Notice of Allowability

10/661,126

EXAMINER'S AMENDMENT

FIG. 6

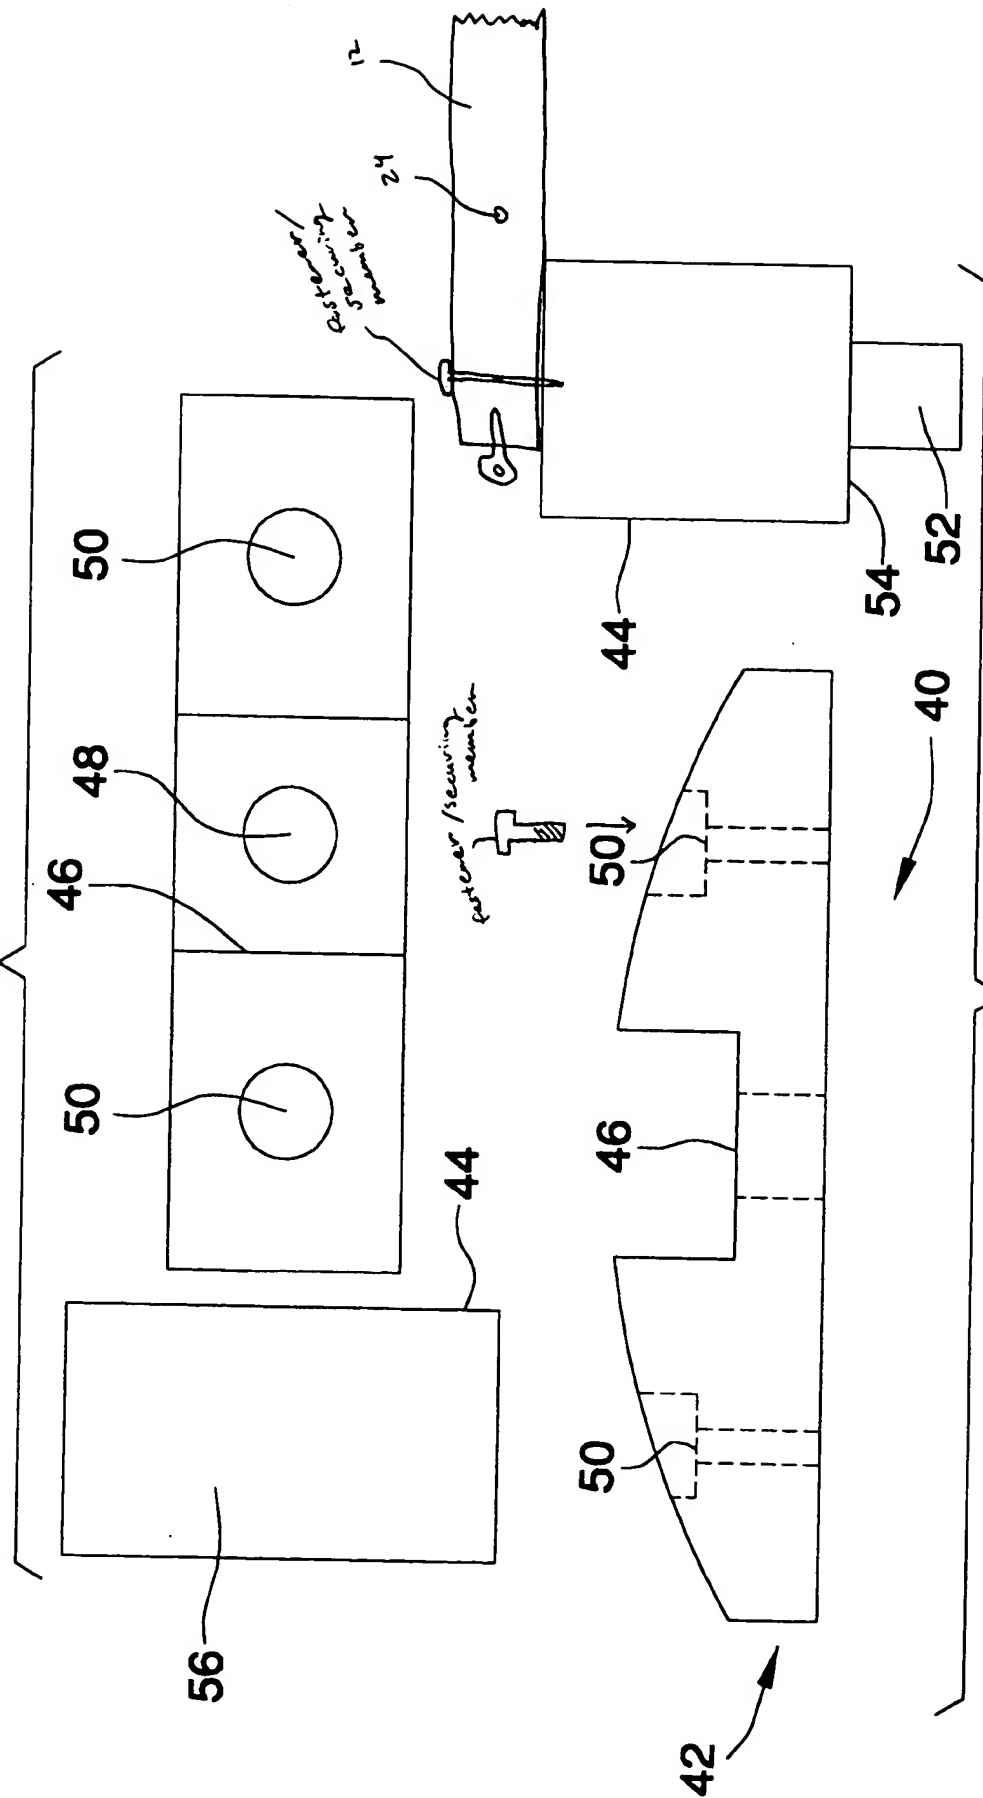
2. The following changes to the drawings have been approved by the examiner and agreed upon by applicant: in Figure 6, fasteners or securing members have been added to show that the mount may be attached to a top edge of a side wall of the vehicle as well as to show the elongate member attached to a top surface of the plate (see marked-up copy hereto attached). In order to avoid abandonment of the application, applicant must make these above agreed upon drawing changes.
